Addendum No. 2
London-Laurel Economic
Development Authority London,
Laurel County, KY
Speculative Building for Greta Lane
Bid Date: June 26, 2023
Issue Date: June 21, 2023

The following additions, deletions, changes or revisions are issued herewith and become a part of the Project Documents. Addendum No. 2 consists of seven (7) 8.5x11 pages, and seven (7) 24x36 sheets.

EC-2

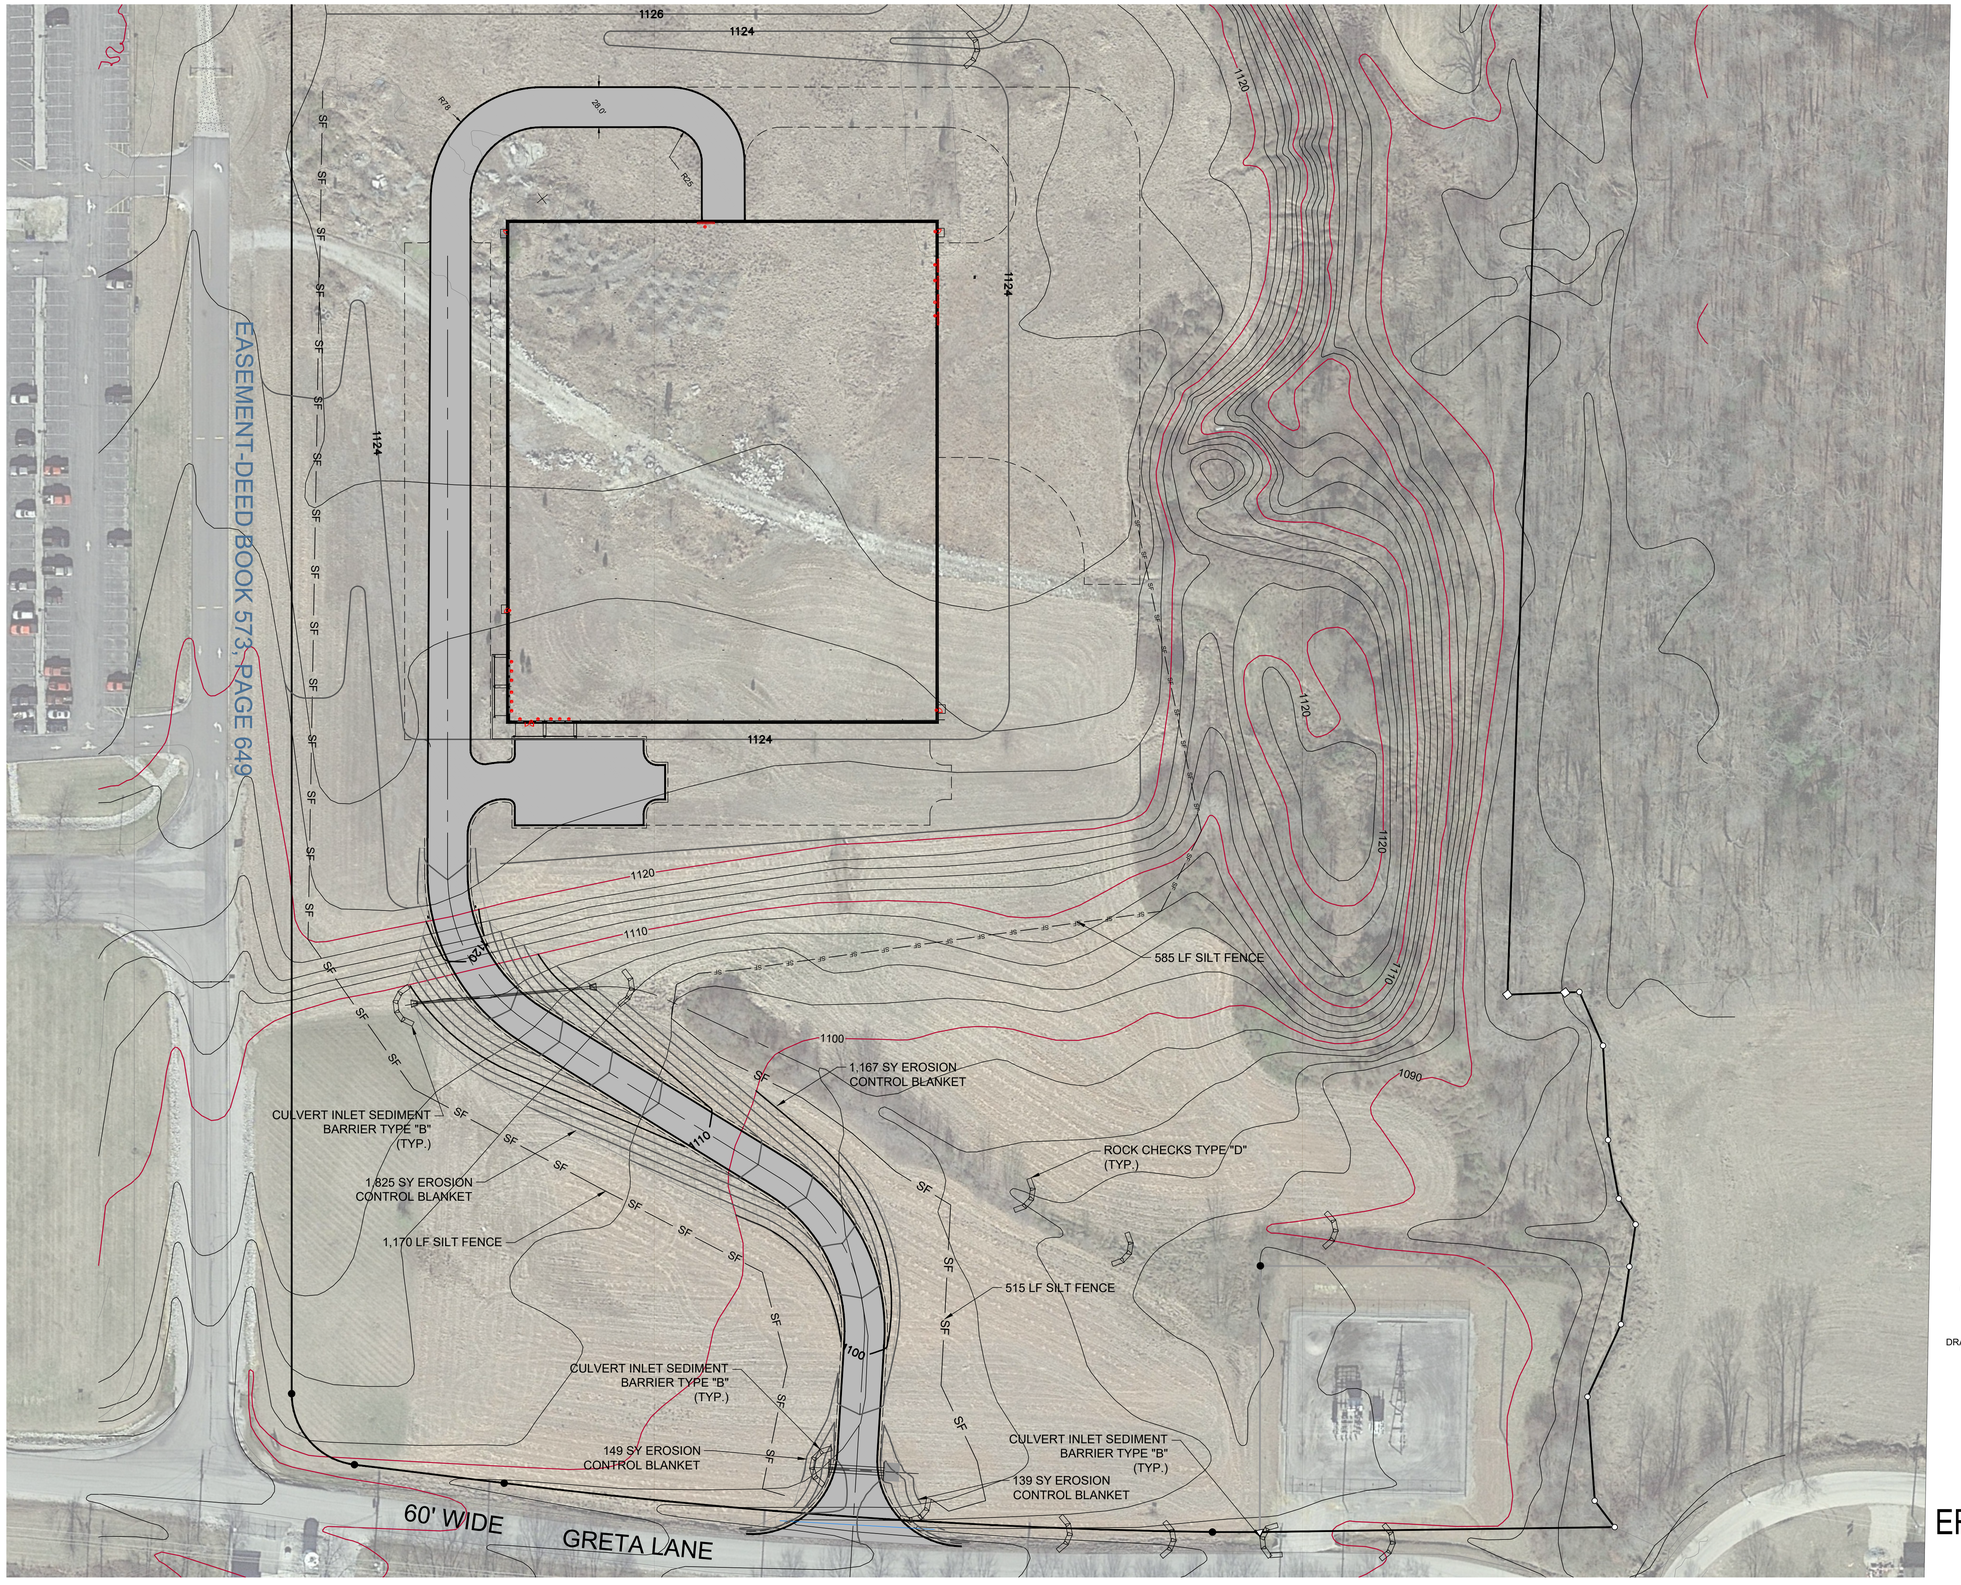
Item 8 – Refer to attached sheet EC-2 dated 6/20/23 with revised erosion control notes. This sheet replaces previous sheet and becomes a part of the contract documents

CUSTOMER JOB NO.:	———
CUSTOMER:	MSE
DRAWN BY:	GSM
DATE:	05.19.23
CKD. BY:	TSM
DATE:	DATE
ASG JOB NO.	23.1193
DRAWING FILENAME:	1193F1.1
DRAWING NO:	F1.1

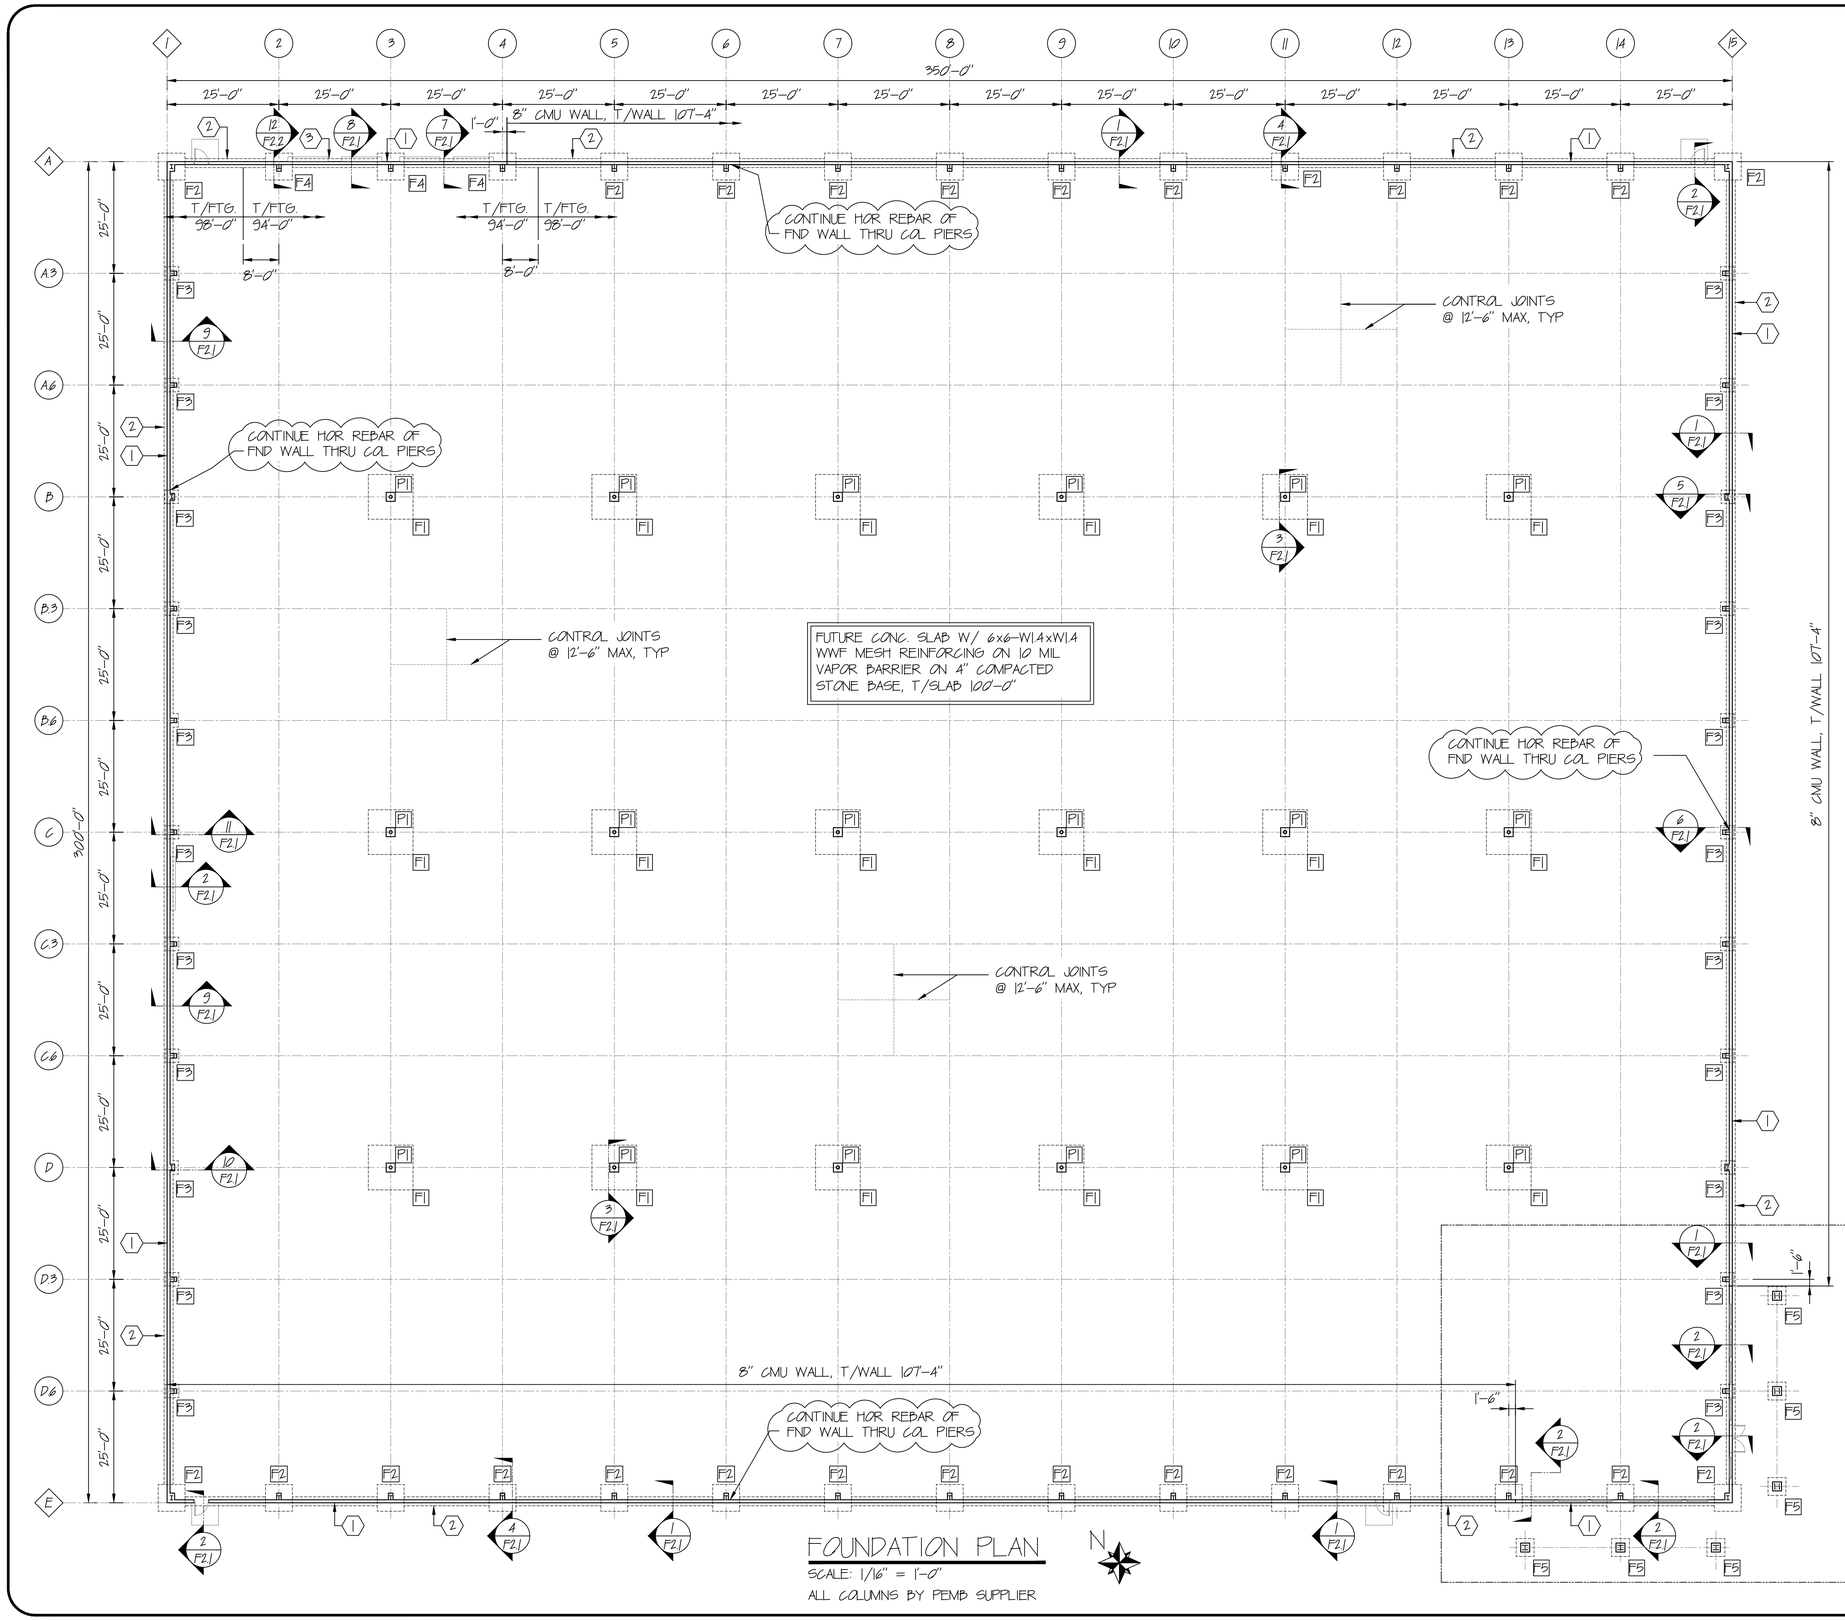
Item 12 – Refer to attached Sheets F1.1, F2.1, F2.2 dated 6/16/23 revised to remove hairpins and provide continuation of reinforcing through column piers. These sheets replace previous sheets and become a part of the contract documents.

Item 15 – Refer to Sheet F1.1, provide an expandable end wall at Column line 1. Replace footing type at column location B1, C1, D1 with F1 footing.

SECTION 7 (F1.1)
SCALE: 3/4"=1'-0"

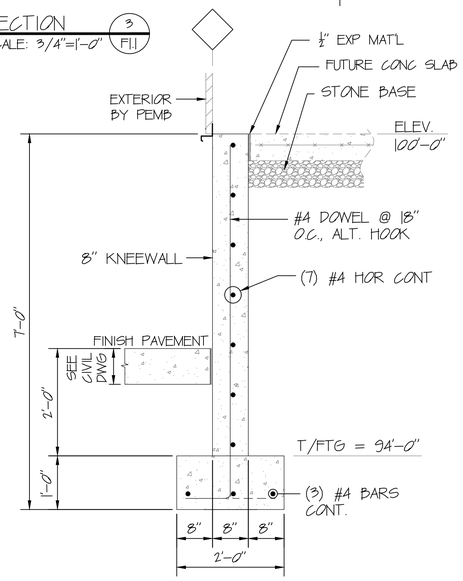
Item 13 – Refer to Sheet F2.1, delete detail 8/F2.1 (shows dock leveling pad) and provide detail 7/F2.1 at future loading docks only. Interior slabs are future work, not in contract. Stem wall to be provided at future loading docks only, coordinate exterior grades with Civil after foundations are installed.

ME-1

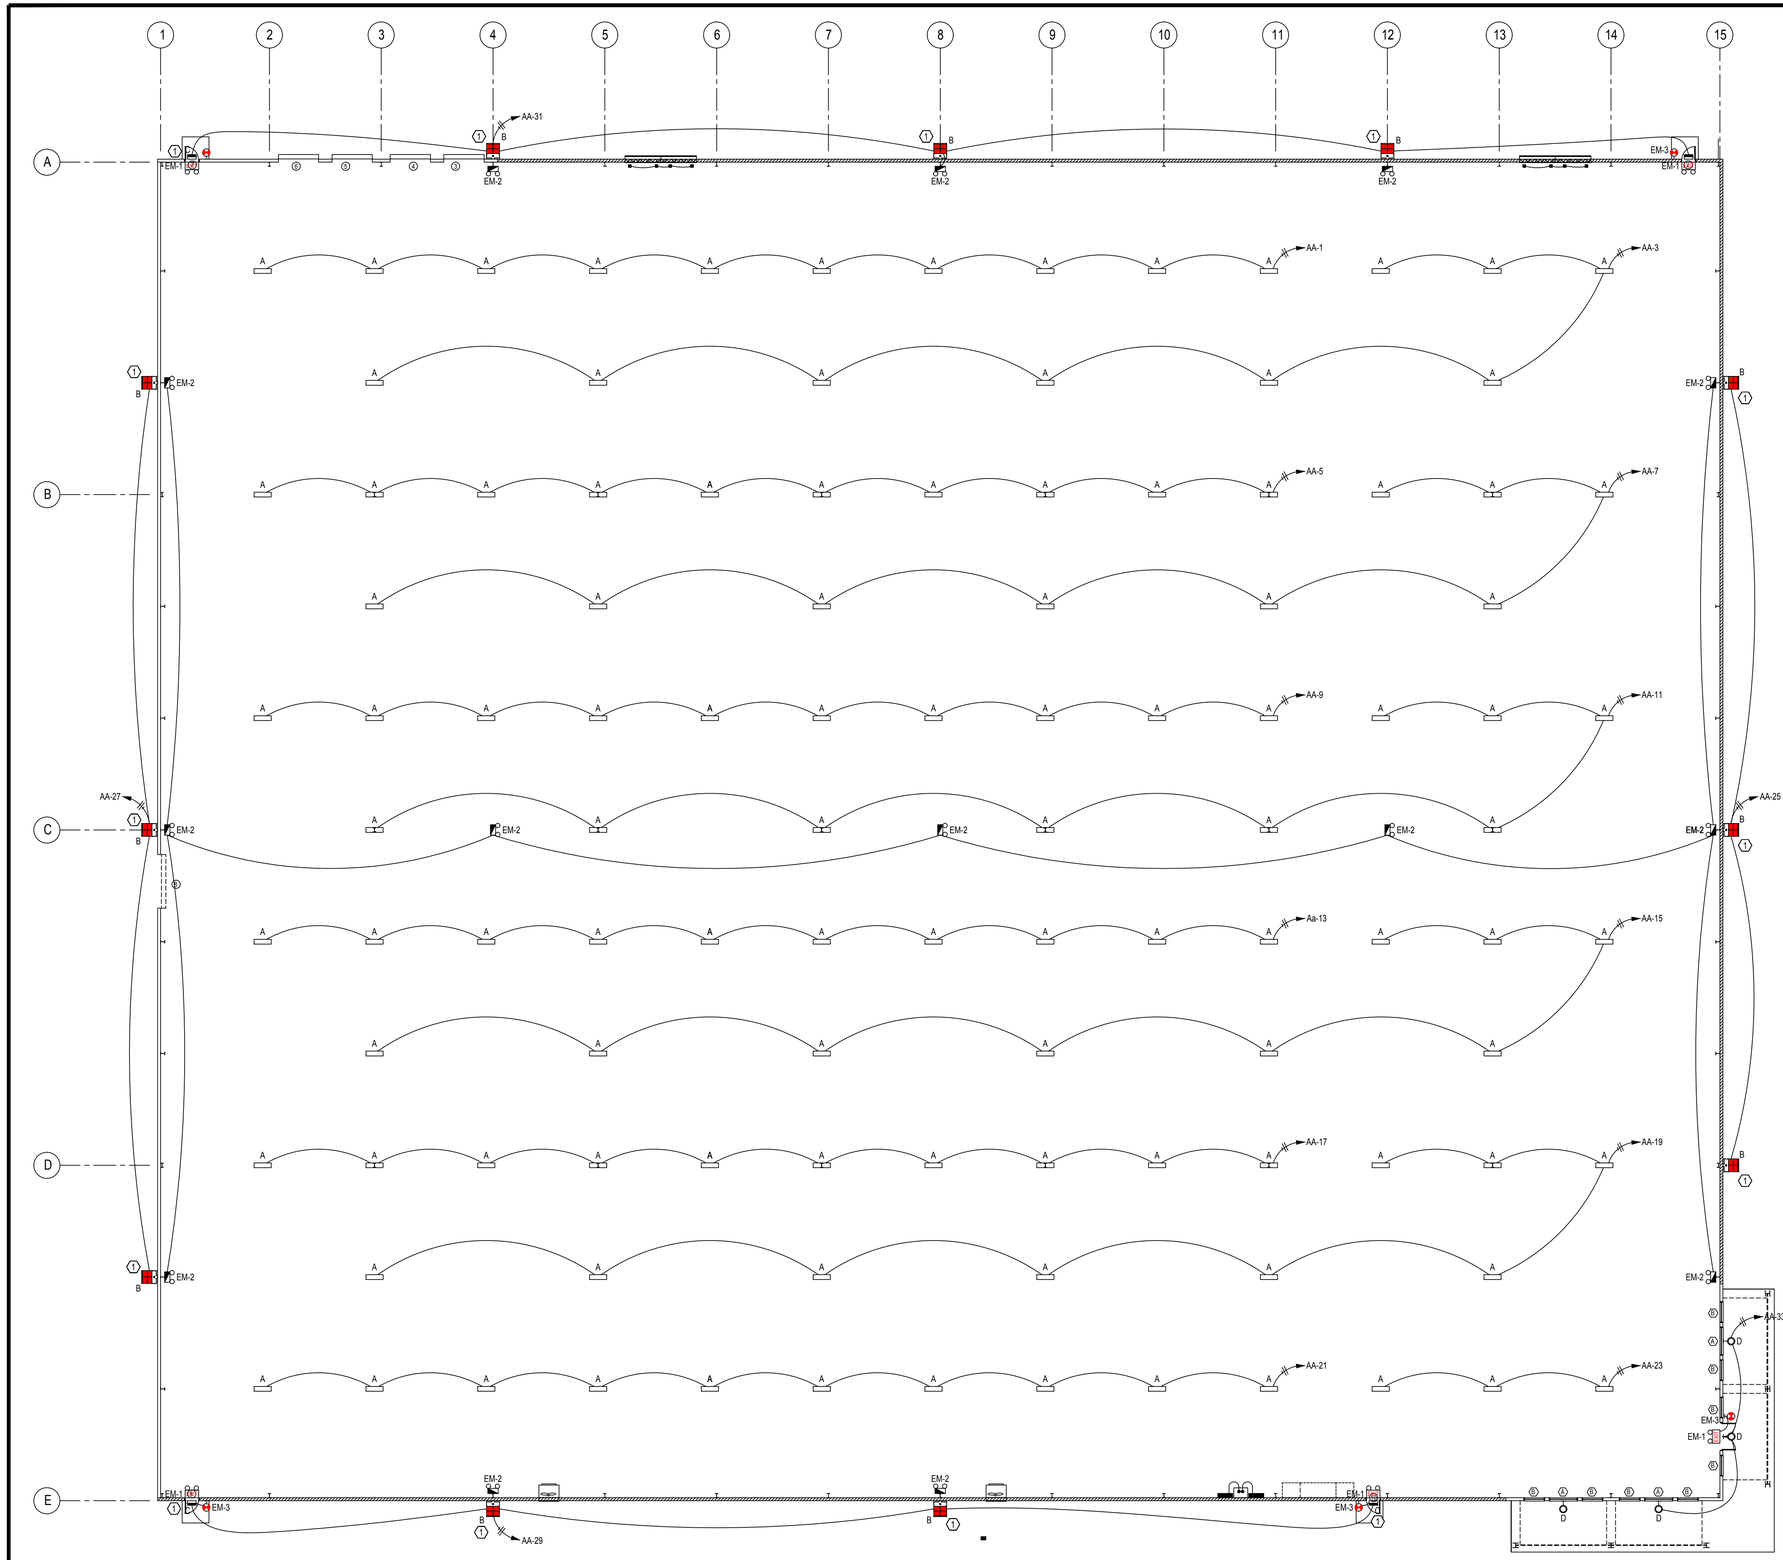
Item 22 – Refer to attached sheets M-1, M-2, M-3 dated 6/16/23 with revisions to lighting fixture schedule and layout. These sheets replace previous sheets and become a part of the contract documents

Type A Revised | Westgate LLHB4-410W-MP -50K-D SCL-GSY10 10ft cable hangers | 46 3/4" x17 ¾" 2" , 53,3000 lumens, 410W,50K 50,000 rated hours, 120-277V, Wide beam angle, 0-10 dimmable, 5 yr warranty , wattage adjustable. | Lamps: LED | Watts: 410W

REVISED 6-15-2023 FIXTURES A, B AND CHANGED CIRCURITY TO FIXTURES A
